SERVICE LETTER

Service Letter Number	Simplex Model	Description of Revision	Revision	Revision Date
SI2012-005 rev.B	508	Revised quantity of fasteners given the substitution allowances. Combined figures 2 and 3	B	September 10th, 2012

Subject: Replacement of fasteners in Turret Assembly.

Applicability: This service letter is applicable to Simplex Manufacturing Model 508 P/N 508-302102-501

Figure 2 Fastener replacement

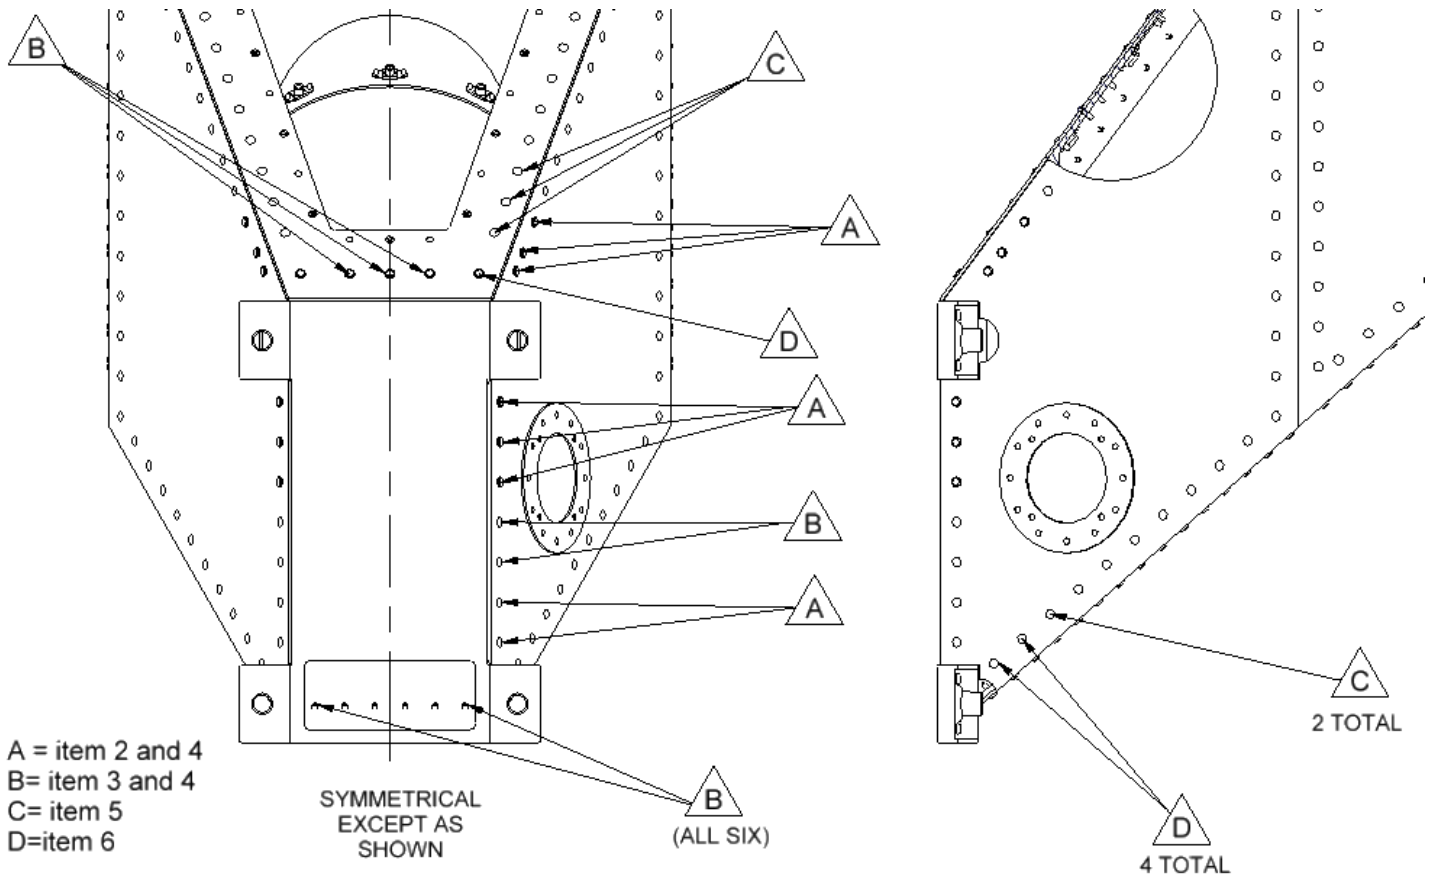
1. Permissible to remove Turret from Box beam Assembly to facilitate fastener replacement.
2. Drill out and discard fasteners shown in fig. 2. Note edge margins prior to removing fasteners shown in fig. 2.
3. Using existing locations, install fasteners IAW fig. 2. HL18-5-x locations require #20 diam drill. CR3213-5-x rivets require #21 drill bit. Deburr holes and brush Alodine and chromate primer affected metal.
4. Touch up fastener heads to match surrounding structure.
5. Re-Assembly turret onto main box beam

REMOVE AND REPLACE FASTENERS AS SHOWN.
ACCEPTABLE TO USE ITEM 5 OR 6 WHERE EDGE
MARGIN OF 1.5D IS UNATTAINABLE FOR ITEM 2 OR 3 HI-LOCK
